TO: Historic Preservation Commission
FROM: Jon R. Oliphant, AICP, Planning & Development Director
SUBJECT: Certificate of Appropriateness Request of Cliff Vieira to Complete Exterior Modifications at 122 N. Main Street
DATE: November 10, 2025

122 N MAIN STREET RE-DEVELOPMENT

122 N MAIN ST, WASHINGTON ILLINOIS

A.5

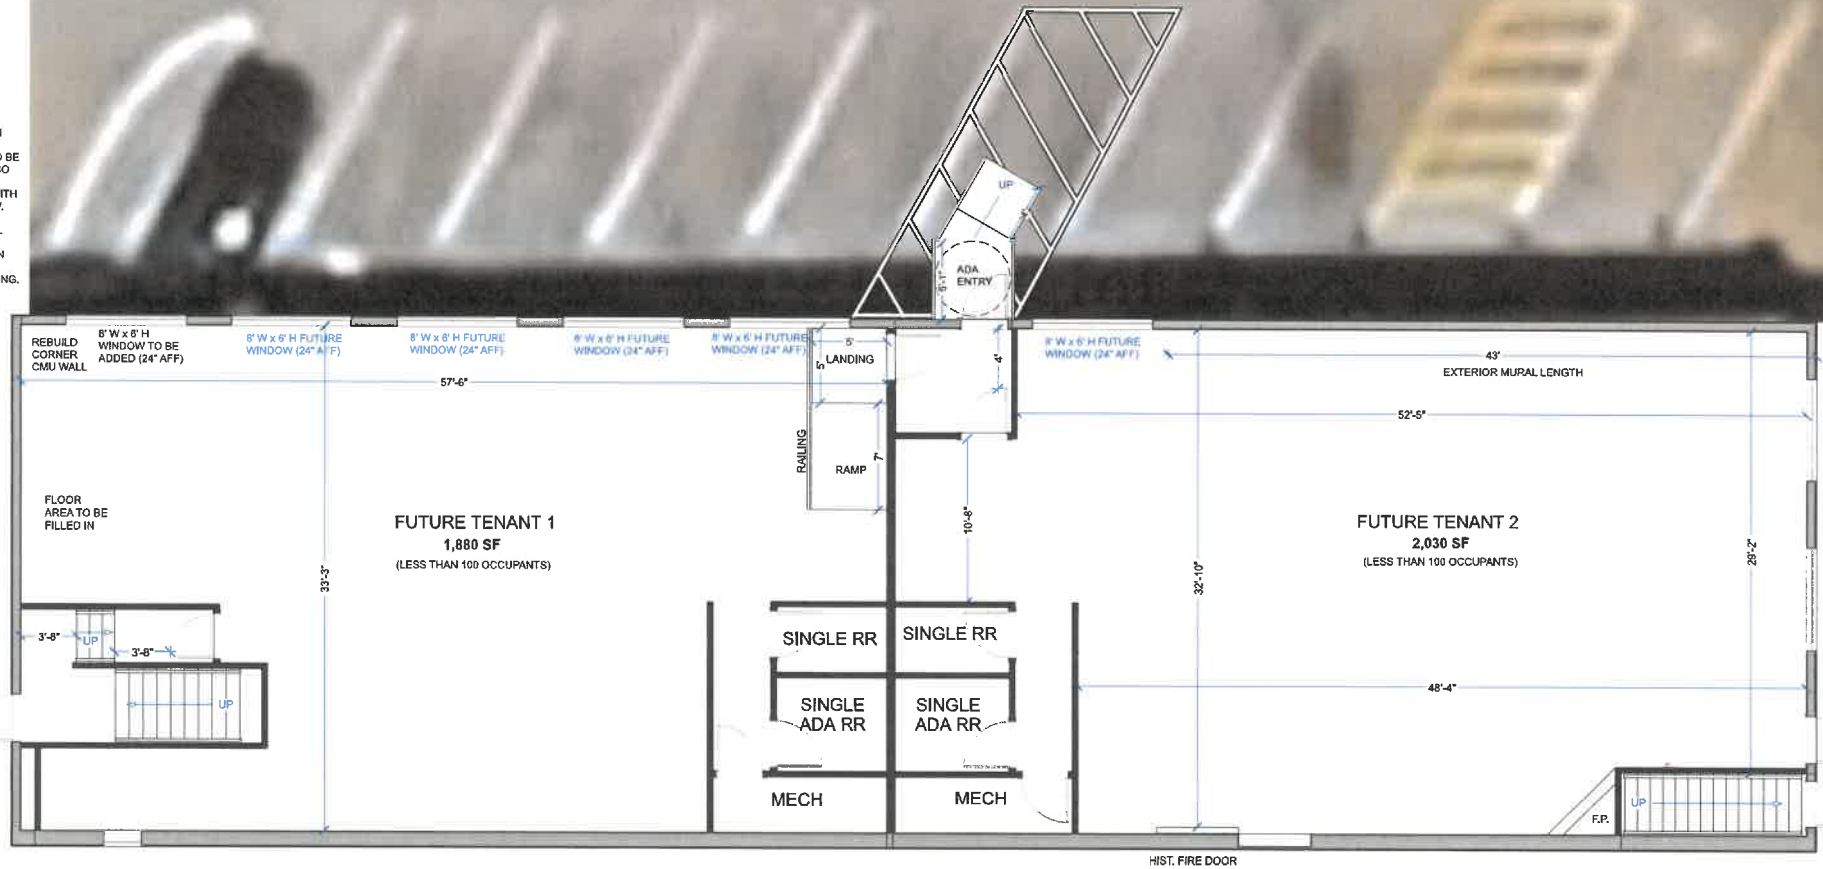
- Section 28-15 (D)(9)(e): Ramps – In order to meet ADA requirements, an approximately 5'-long concrete ramp is proposed to extend from the new door into the parking space that would be removed. Adding a ramp on the north façade would eliminate any need to have a ramp at the N. Main entrance.

- Section 28-15 (E)(1): Awnings – An awning is proposed to be placed above the new entrance. The awning is intended to meet 2018 International Building Code regulations to provide shelter from inclement weather upon entering and exiting. It would be black and scaled appropriately for the door area. The owner and architect have indicated that a metal awning is proposed instead of fabric due to the long-term durability and ensuring that it be aesthetically pleasing for a longer period of time.

HVAC UNIT ON NORTH ELEVATION TO BE RELOCATED SO DOES NOT INTERFERE WITH NEW WINDOW.
REBUILT WALL PAINTED CHARCOAL ON EXTERIOR TO MATCH EXISTING.
